**TITLE: NAVIGATION - GENERAL - REPLACE AOA PROBE CONIC PLATE BY  
AOA PROBE FLAT PLATE**

SERVICE BULLETIN No.: A340-34-5093

# A340-500/600

MODIFICATION No.: 203295S32646

Figure A-FSAAA - Sheet 01

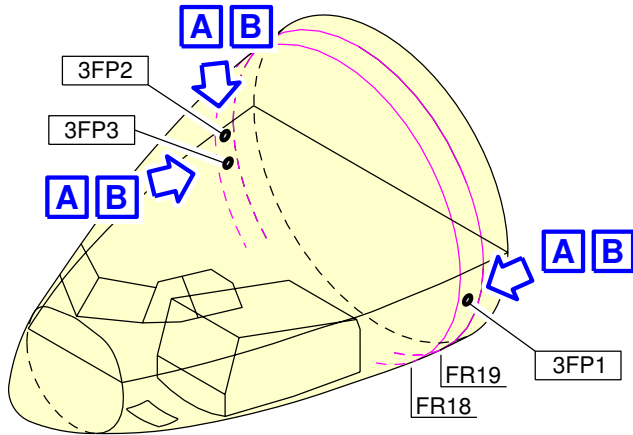
This modification requires the removal of the conic plates PN F3411060200000 and PN F3411060900000, and the installation of flat plates PN F3411007920200 (LH) / PN F3411007920300 (RH).

TYPICAL ILLUSTRATION ASSOCIATED WITH THALES OR GOODRICH AOA SENSORS.

Figure A-FSBAA - Sheet 01

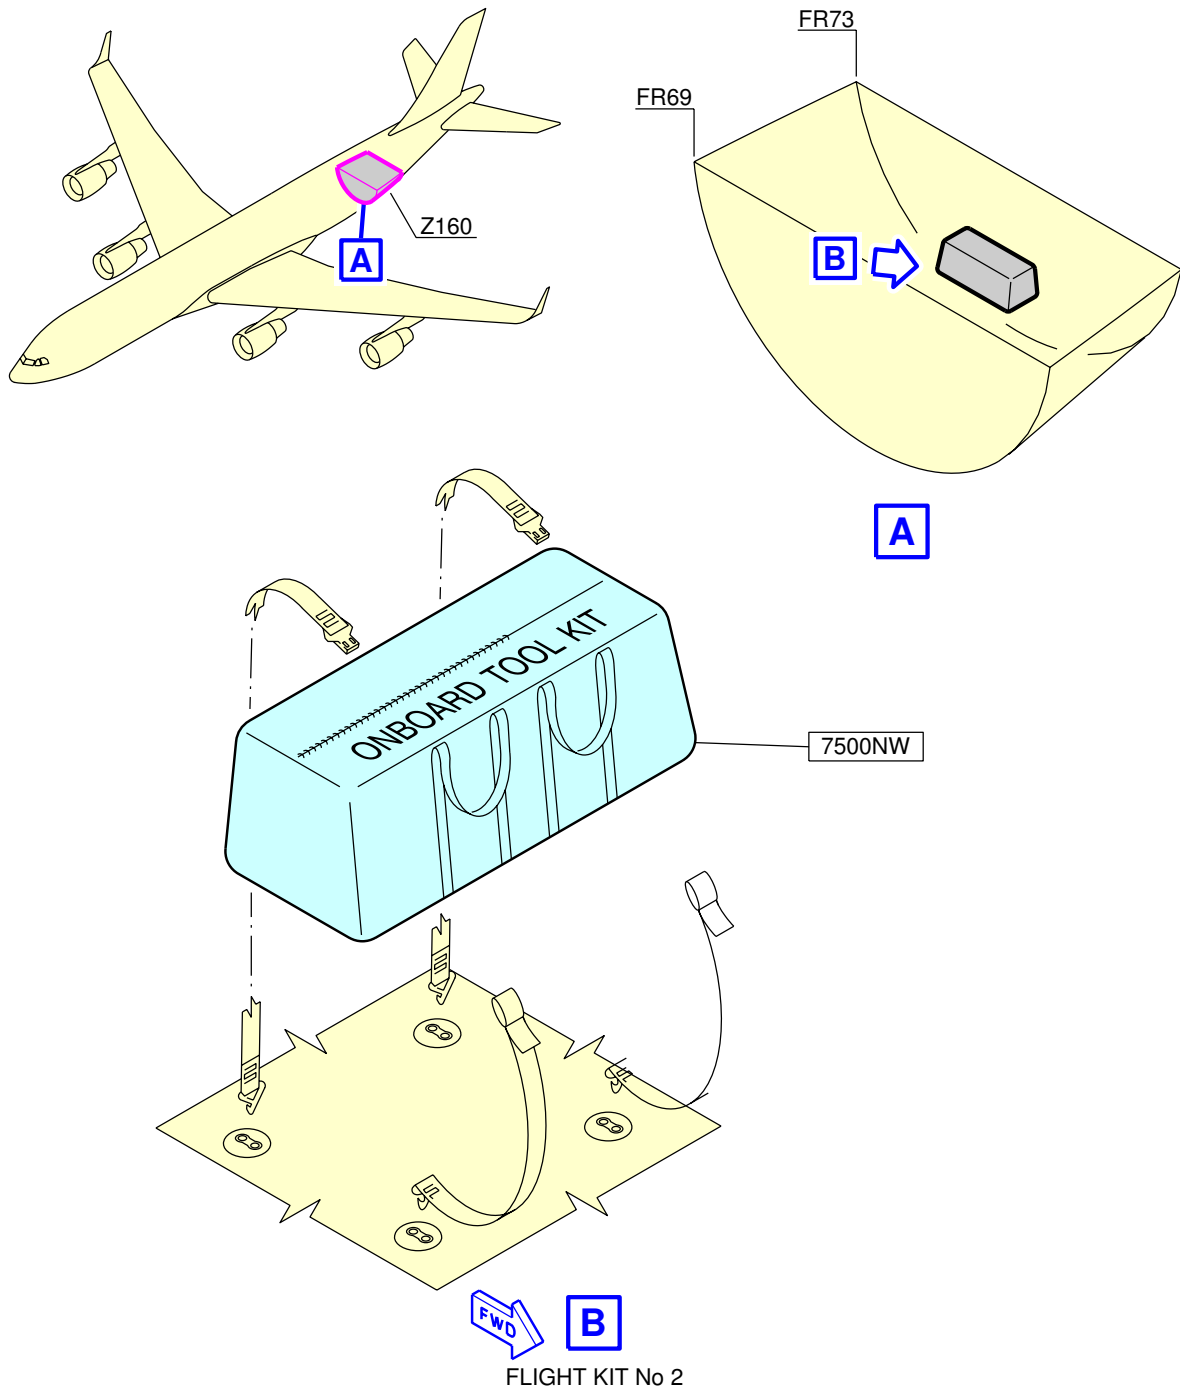
Also, it requires to change the 3 AOA Sensor Protection Covers (FINs 7955ME, 7956ME and 7957ME) stored in Flight Kit No 2 (FIN 7500NW or FIN 7503NW).

AOA PROTECTION COVERS FINs (7955ME, 7956ME AND 7957ME)  
ARE STORED IN FLIGHT KIT No 2 FIN (7500NW)

Figure A-FSBAB - Sheet 01

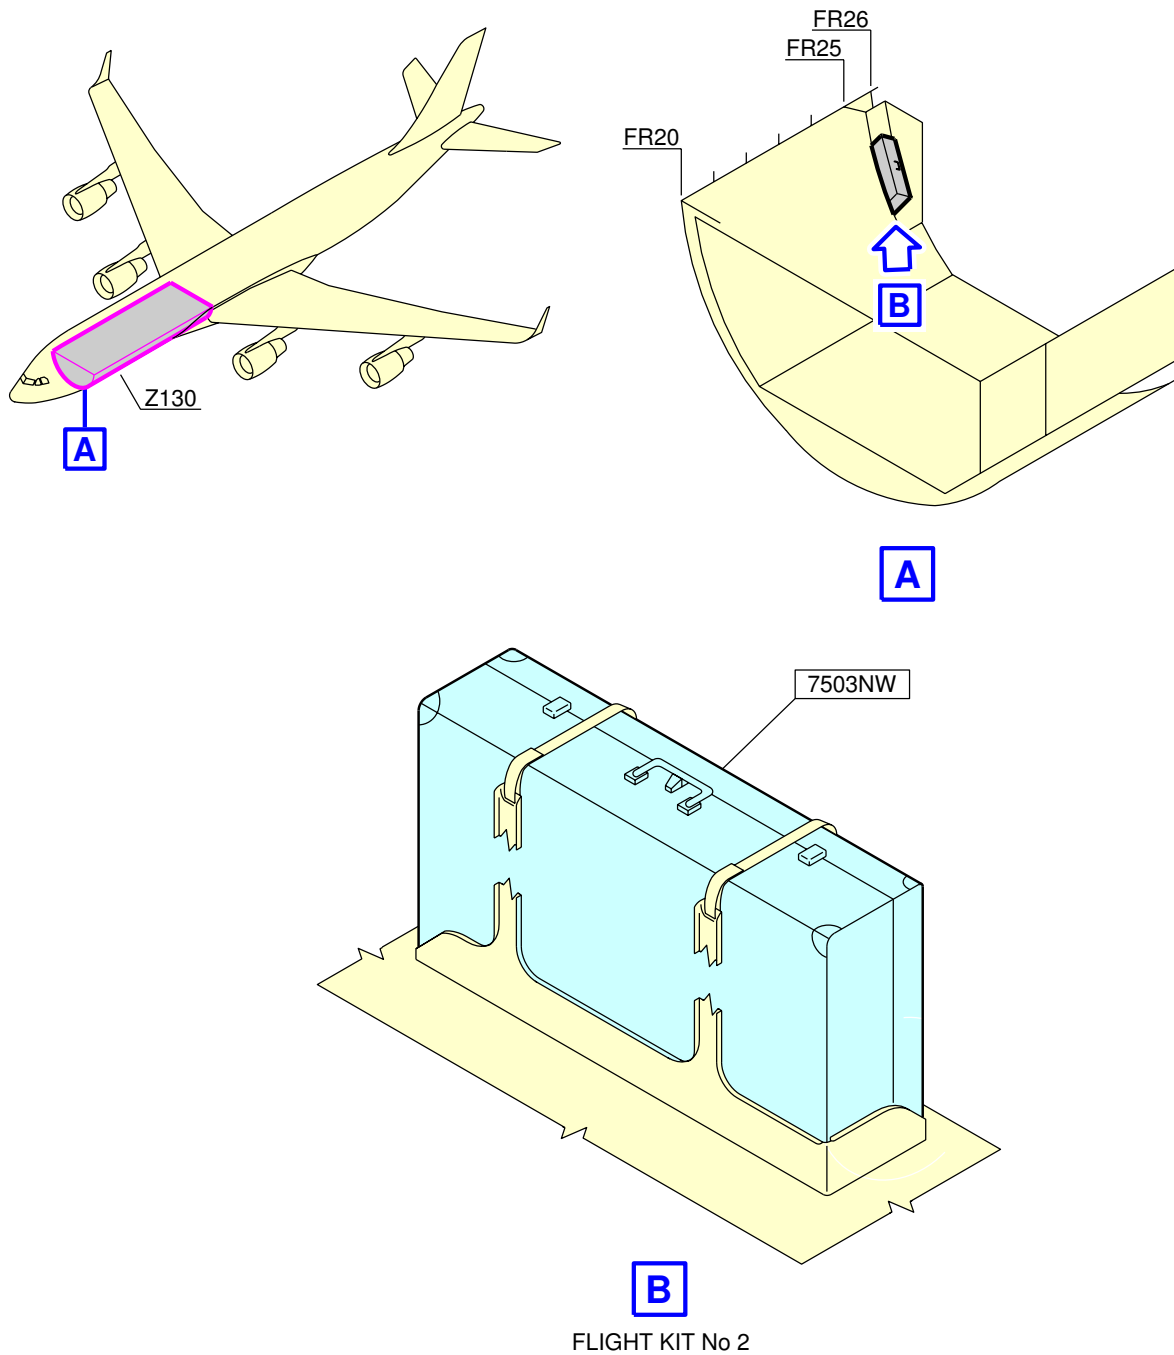
AOA PROTECTION COVERS FINs (7955ME, 7956ME AND 7957ME)  
ARE STORED IN FLIGHT KIT No 2 FIN (7503NW)

Figure A-FBAAA - Sheet 01  
Modification of the Plates

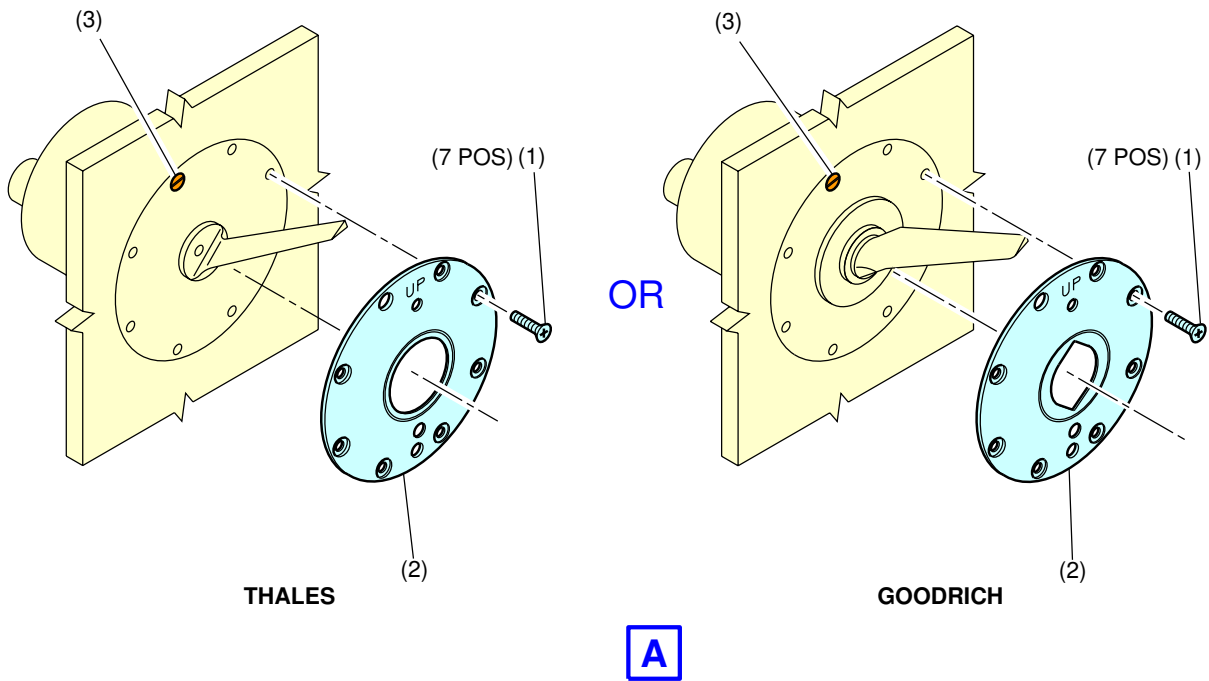
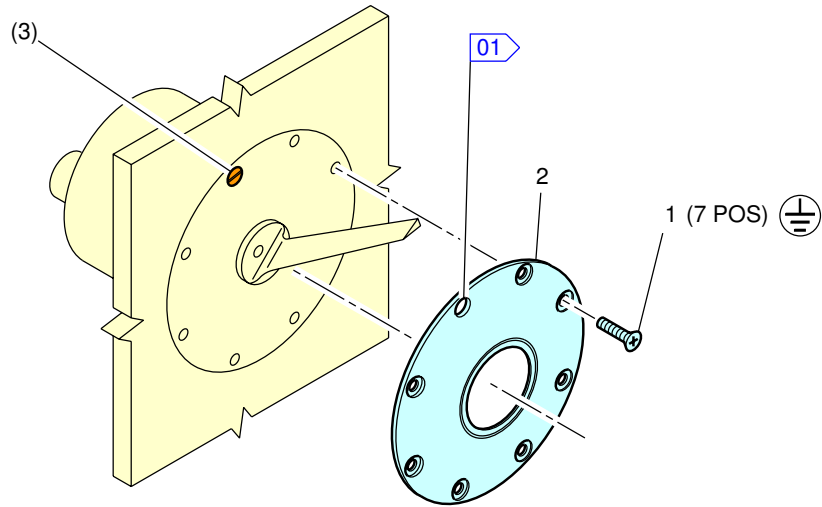
(a) Replace the conic plate by the flat plate of the AOA Sensor FIN 3FP1:

2 Remove the conic plate:

Refer to [Fig. A-FBAAA Sheet 01](#)

Refer to [Fig. A-FBAAA Sheet 02](#)

- (a) Protect the screws Item 1 in accordance with ESPM 20-51-20 and AMM Task 20-28-00-912-802 and/or AMM Task 20-28-00-912-804.
- (b) Blank off the hole located in front of the screw item (3) in accordance with SRM 51-24-00 and as shown on [Fig. A-FBAAA Sheet 02](#) with:

Figure A-FBBAA - Sheet 01  
Modification of AOA Protection Covers in the Flight Kit No 2

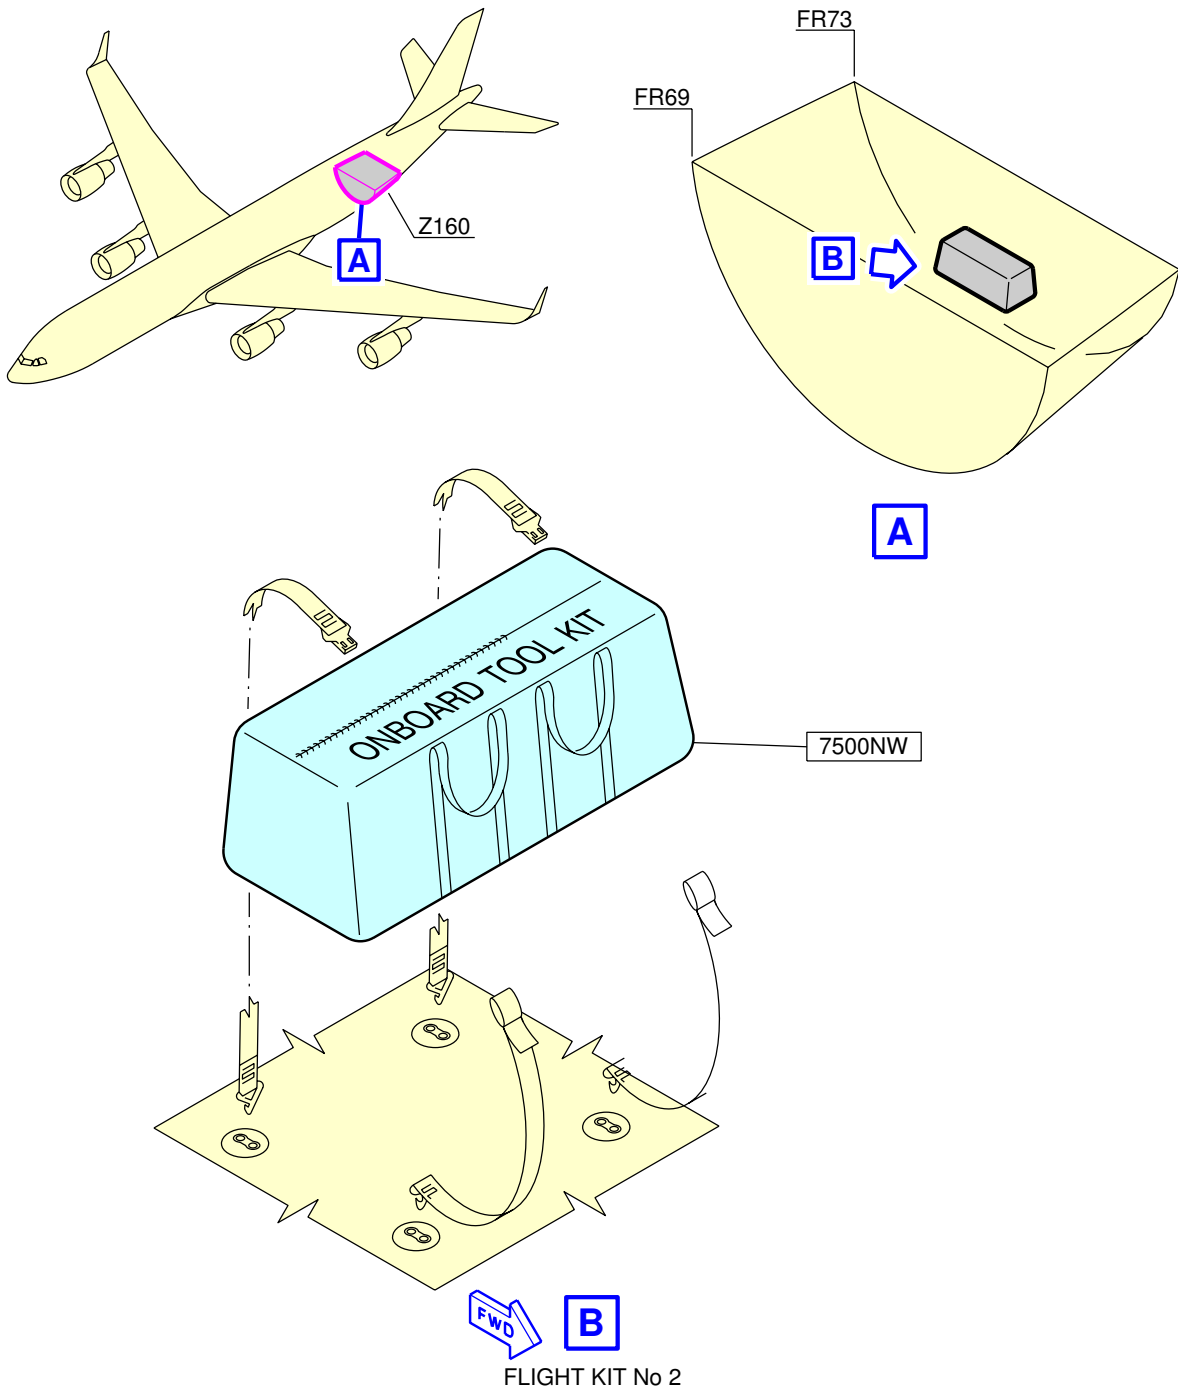
(a) Remove in the Flight Kit No 2 (FIN 7500NW):

Refer to [Fig. A-FBBAA Sheet 01](#):

Figure A-FBBAB - Sheet 01  
Modification of AOA Protection Covers in the Flight Kit No 2

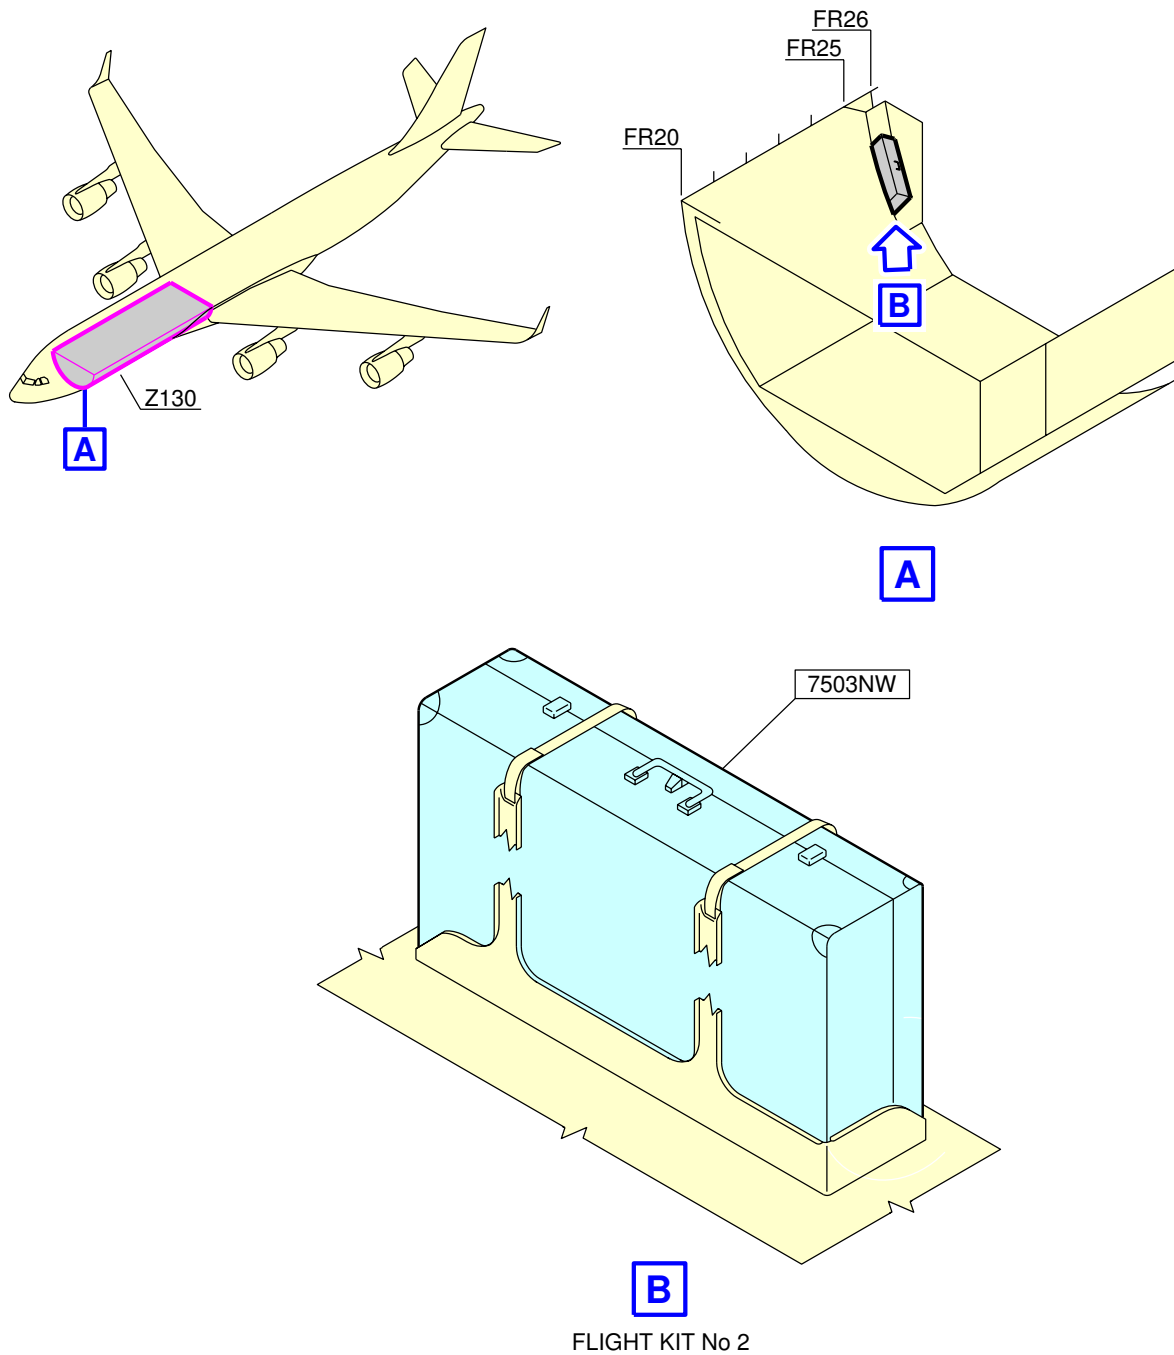
(a) Remove in the Flight Kit No 2 (FIN 7503NW):

Refer to [Fig. A-FBBAB Sheet 01](#):
